October 10, 2023

Edward Coffland, P.E., Public Facilities Director
Haines Borough
PO Box 1209
Haines, AK 99827

RE: DR-4585 PW 13 - FEMA Questions for Porcupine Road (EHP RFI)
Response to 9/20/2023 Request for Information

**TYPICAL
SECTION**

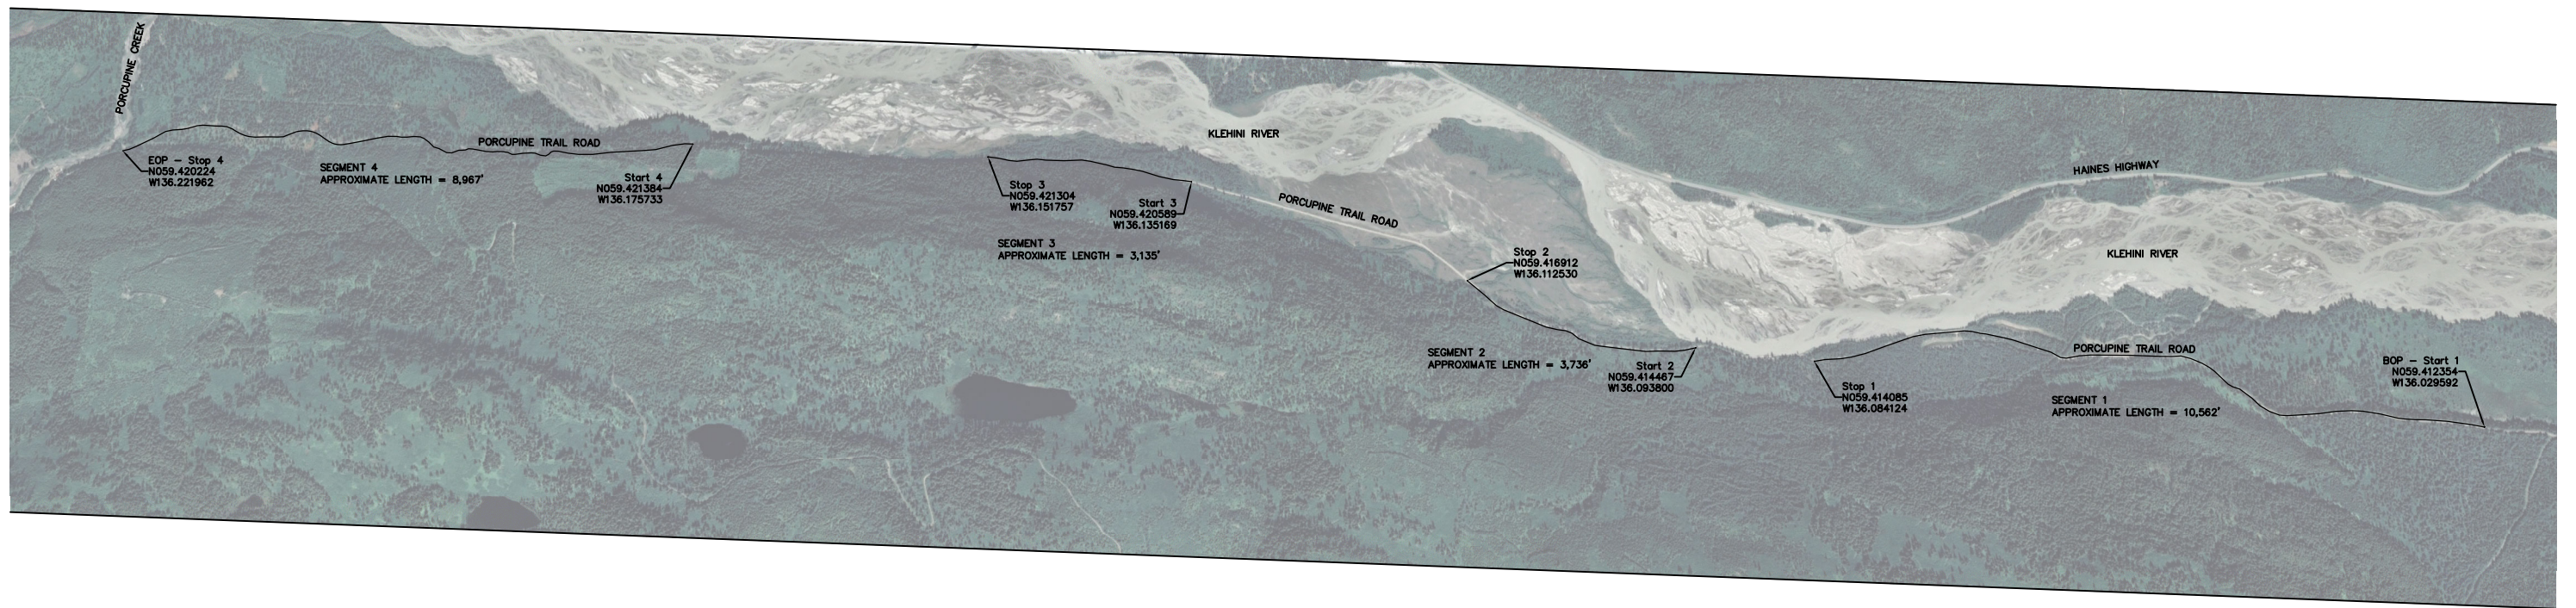
- 2) Please identify the SOW for the sections that were completed for the Phase I (City and 3rd party) and any modifications for the approved scope of work (22-foot, with ditch repairs).

Response: Refer to Attachment B for copy of Haines Borough FEMA-funded Phase I project plans, as well as an excerpt containing Specification Section 303 Reconditioning. A complete copy of the Phase I contract, including specifications, can be furnished upon request. There were no Borough-directed modifications to the Phase I approved scope of work during or prior to construction that resulted in changes to the width of roadway surfacing, reconditioning of ditches and shoulders, or limits of anticipated disturbance. A bidder question was posed on 6/29/2022 (during public advertisement of the construction contract) regarding the 22' width called for in the plans, and fact the existing roadway width varied, questioning what finished width requirement was to be followed. The Haines Borough responded the same day, stating "Our intent is for the reconditioned road surface to match the existing road surface up to 22 feet wide. Where the existing road surface is less than 22 feet wide, we do not intent to widen the, but recondition to match the narrower road." See Attachment B for Q&A History from bidding process, which contains the exchange noted herein.

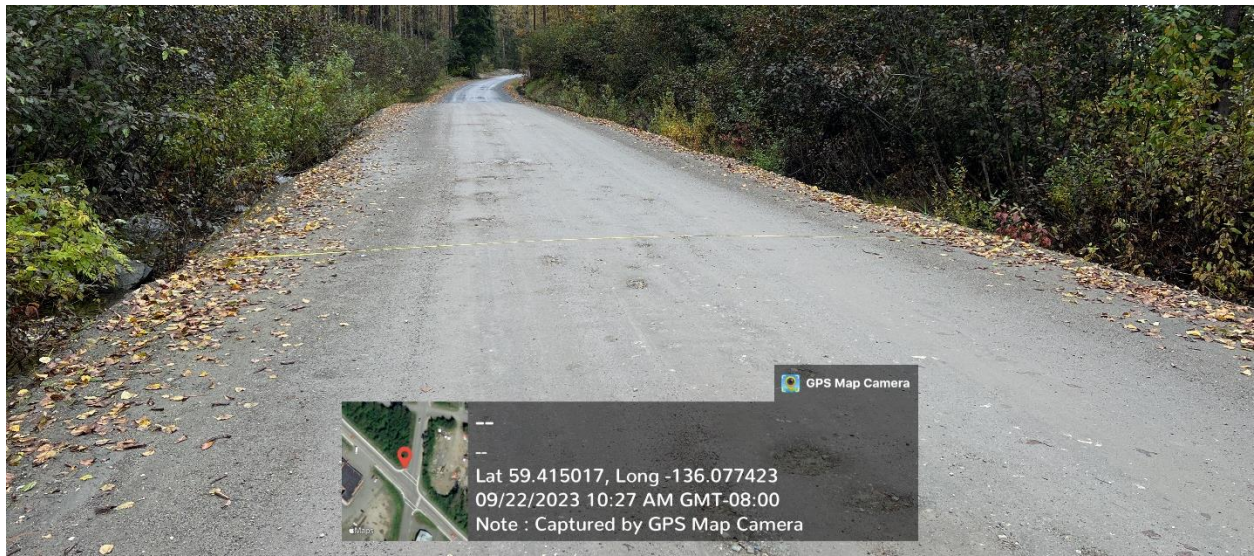
The document that you (Jenny) provided via email yesterday noted that road sections were raised by the 3rd party. Inherently, raising sections of road would result in a wider road prism, please identify sections of road were raised, and the resulting width and disturbance: Where the width of the road/ditch/disturbance was increased beyond the pre-disaster limits.

Response: Refer to Attachment C for Third-Party Plans and Scope of Work Narrative. The only modification to Third-Party scope of work we are aware of was the separating of First Road Lift work limits into two segments (see response to Item 1 above). The existing, pre-disaster roadway was not 22' wide over its' entire 7.5-mile length; roadway widths varied throughout the corridor, both wider and narrower than the Phase I proposed 22' driving surface width. The Phase I as-built width of driving surfaces on Porcupine Trail Road is actually less than 22' wide in many locations, and wider in some, as was documented during the 8/31/23 site visit by FEMA EHP representatives. This condition is restated to emphasize that constructing a finished 22'-wide top driving surface over a 3' thick fill will not necessarily result in widening the existing road or disturbing areas outside of the existing right of way/roadway prism.

Figure C.3 – Cross section of third-party work site 1 fill area on Porcupine Trail Road, outside of Phase I work limits. Edge of shoulder to edge of shoulder width is 28’ at this location, and width to outside edges of travel lanes (driving surface) is 19’. Third-party work at this site was placement of 3’ fill only – no gravel surfacing or riprap materials were placed. Photos of measurements can be provided upon request.

Figure C.8 – Riprap placed at third-party work site 3 on Klehini River side of roadway fill slope above ordinary high water. Note the presence of existing uplands vegetation between toe of fill and river.

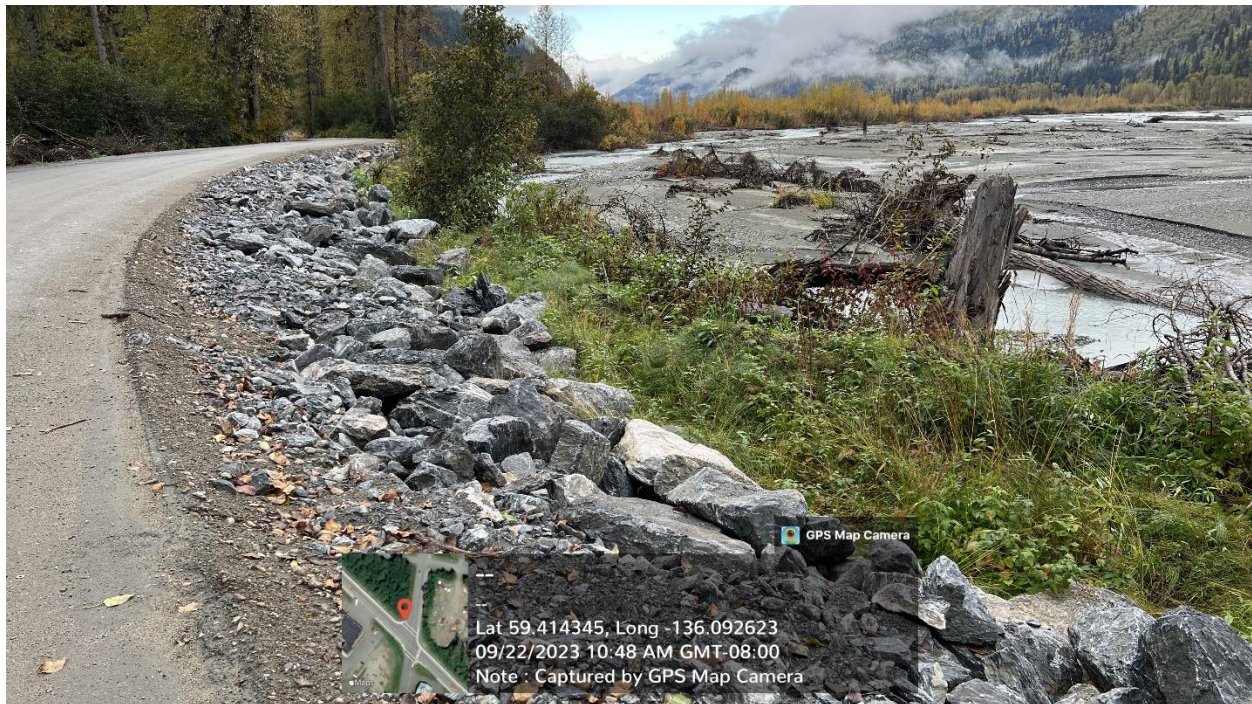
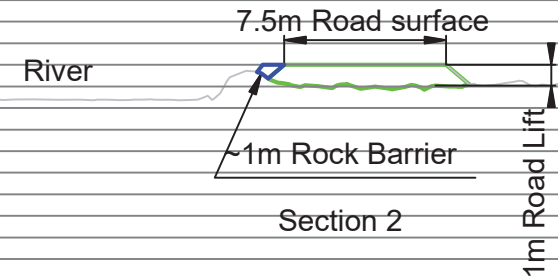
- 4) During the 8/31 site inspection, work was noted to be completed by the 3rd party associated with a culvert that conveys flows of Herman Creek, and fill might have been placed in the creek beyond the road prism? (if applicable, see permitting compliance below: USACE 404/Alaska Dept. Fish and Game habitat permit).

Figure C.9 – Riprap placed at third-party work site 3 on Klehini River side of roadway fill slope above ordinary high water. Note the presence of existing uplands vegetation between toe of fill and river, as well as the existing undisturbed roadway grade at toe of fill in foreground.
